**Re: Buffalo Ridge Wind, LLC – Certificate of Need – Second Application Amendment**

**MPUC Docket No. IP-IP7006/CN-19-309  
OAH 82-2500-36550**

# Buffalo Ridge Wind Energy Center Turbine Layout Comparison

**Figure 1. Project Layout**

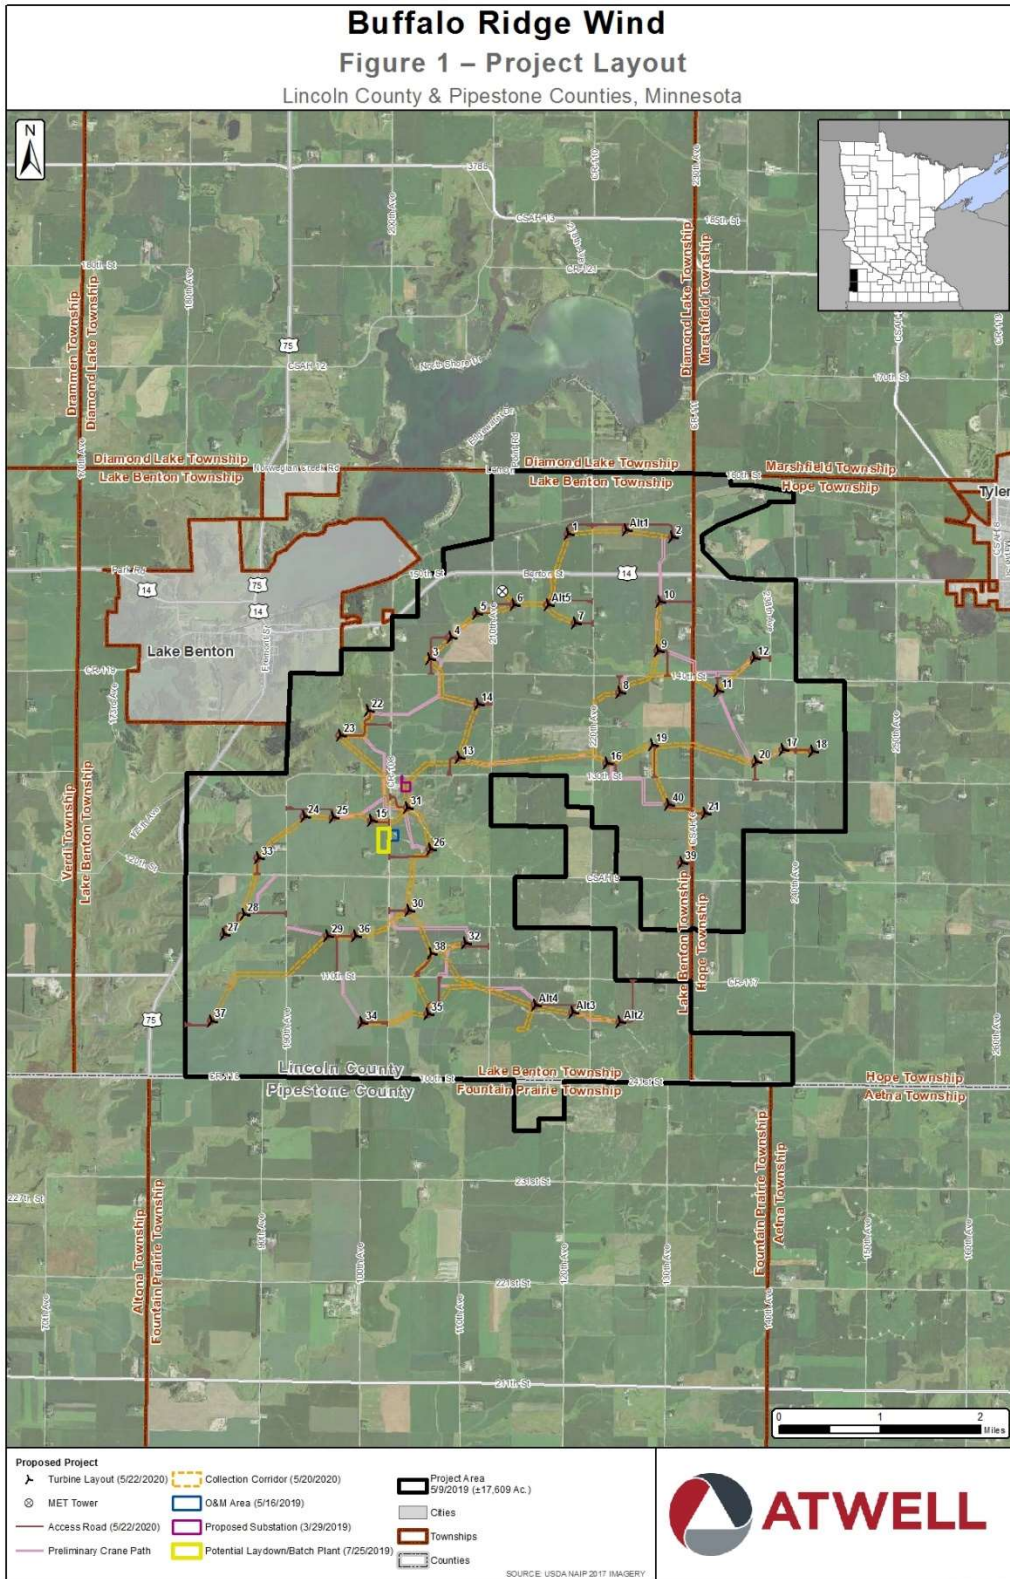
More specifically, this Second Application Amendment proposes to change the four GE 2.3 MW safe harbor wind turbines to GE 2.52 MW turbines, as well as change two of the alternative GE 2.82 MW turbines to GE 2.52 MW turbines. A total of 36 GE 2.82 MW turbines and three alternative GE 2.82 MW turbines remain unchanged since the First Application Amendment. A map comparing the Initial Application wind turbine array, the First Application Amendment wind turbine array, and this Second Application Amendment wind turbine array is provided in **Attachment A**. Access roads, collection routes, and crane walks were adjusted to accommodate the revised turbine array, which can be seen in **Figure 1**, below. **Table 1** provides a summary of the wind turbine design changes.<sup>3</sup>

The Initial Application stated that three turbine models would be used for the Project, including: 31 GE 2.82 MW wind turbines, five GE 2.52 MW wind turbines, and four GE 2.3 MW wind turbines. In the First Application Amendment, the five GE 2.52 MW wind turbines were proposed to be replaced with GE 2.82 MW wind turbines for a total of 36 GE 2.82 MW wind turbines and four GE 2.3 MW wind turbines. The current project layout is now proposed to utilize four GE 2.52 MW turbines rather than the four GE 2.3 MW wind turbines proposed in the First Application Amendment. The GE 2.52 MW turbines have a 116-meter rotor diameter (RD) with 90-meter towers. As both the GE 2.52 MW turbines have the same hub height as the GE 2.82 MW turbines and the same RD as the GE 2.3 MW turbines, this change is negligible. A map showing the updated Project is provided below in **Figure 1**.
